## **Application by RWE Renewables UK Solar and Storage Limited for Peartree Hill Solar Farm (EN010157)**

### **The Examining Authority's (ExA's) second written questions and requests for information (ExQ2)**

**Issued on 24 September 2025**

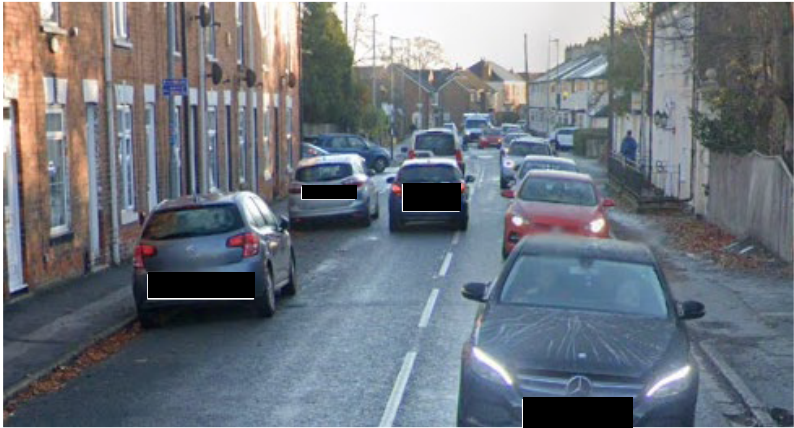
ExQ2	Question to:	Question:
13.	Transport and access	
2.13.1	ERYC	<p><b>Use of Park Lane during construction</b></p> <p>The applicant has responded (on pages 19 and 20 of [REP2-037] and pages 71 to 74 of [REP2-038]) to your concerns regarding the use of Park Lane during construction (and has committed to the restriction of the use of this route around school drop off and pick up times (oCTMP paragraph 6.1.8 [REP2-142])). You will also note the observations in the note of the ExA's unaccompanied site inspection (USI2 [EV1-002])). Please:</p> <ol style="list-style-type: none"> <li>Confirm whether the applicant's response addresses your concerns, and if not, the reasons for this; <a href="#">The response does not address or satisfy the council in terms of its concerns regarding the use of Park Lane and the PROW.</a></li> <li>If it does not address your concerns, clarify, with supporting evidence your views on the severity of any impact/ effect, noting that the LIR states at paragraph 7.74 that '[...] the use of Park Lane could have significant impact [...]' whereas paragraph 7.114 states 'It is considered it would have a negative impact on highway safety and residential amenity [...]', and is thus not clear on the matter; and <a href="#">The most recent seven-day traffic count that has been undertaken by ERYC located near on Park Lane near Henson Drive in September 2020 which identified an HGV rate of 0.2% of average daily trips of 1154. This equates to an average of less than 3 two-way HGV movement per day. Therefore, any increase that may be considered modest along Northgate would be considered fairly significant along this section of Park Lane. The traffic count information is submitted as <b>Appendix A.</b></a></li> </ol> <p><a href="#">The Visibility at the Junction with Park lane and Northgate is very limited due to existing dwellings and the tight radii (See figure 1). The Departure side (left is acceptable and complies with Manul for Streets, however the arrival side (right) is very restricted and only has 2.4 x 18m visibility splay to the nearside kerb and does not comply with the 2.4 x 43m for a 30mph speed limit. An OS based drawing showing the visibility splay is shown in <b>Appendix B.</b></a></p>

ExQ2	Question to:	Question:
		<div></div> <p>Figure 1: Arrival side junction visibility looking west along Northgate from Park Lane</p> <p>The junction is so constrained that limited number of HGVs that typically use this junction over run the footpath due to the tight radii on the western side of the junction, see figure 2.</p> <div></div> <p>Figure 2: Damage to Kerbing and footpath due to HGV overrun on Park Lane Junction</p>

ExQ2	Question to:	Question:
		<p>It is understood that the applicants consultants have recommended that HGVs do not deliver or depart the site during the school pick up and drop off time, however the only school likely to be affected is over one mile away from the site entrance on Park Lane and on a busy B classified road (B1233). The school facilitates an area off the road for drop offs and pick up, although there are often drop offs and picks up outside the area, whilst the council welcome the idea of avoiding these times, the grave concern is more in relation to the Park Lane and its junction with Northgate.</p> <p>c) Provide your view, noting NPS EN-1 paragraph 5.14.21, as to whether there would be an unacceptable impact on highway safety? <a href="#">Para 5.14.21 states The Secretary of State should only consider refusing development on highways grounds if there would be an unacceptable impact on highway safety, residual cumulative impacts on the road network would be severe, or it does not show how consideration has been given to the provision of adequate active public or shared transport access and provision.</a></p> <p>It is the Local Highway Authorities opinion that give the details outlined above the development could have an unacceptable impact on highway safety. This is specifically in relation to the use of the Park lane/Northgate Junction and the sue of the PROW as a haulage route.</p> <p>If the inspector is minded to allow the use of Park Lane for construction the council would like to see further restrictions such as construction traffic along park lane is only permitted between 09:30-15:00, avoiding the school and network traffic peaks.</p>
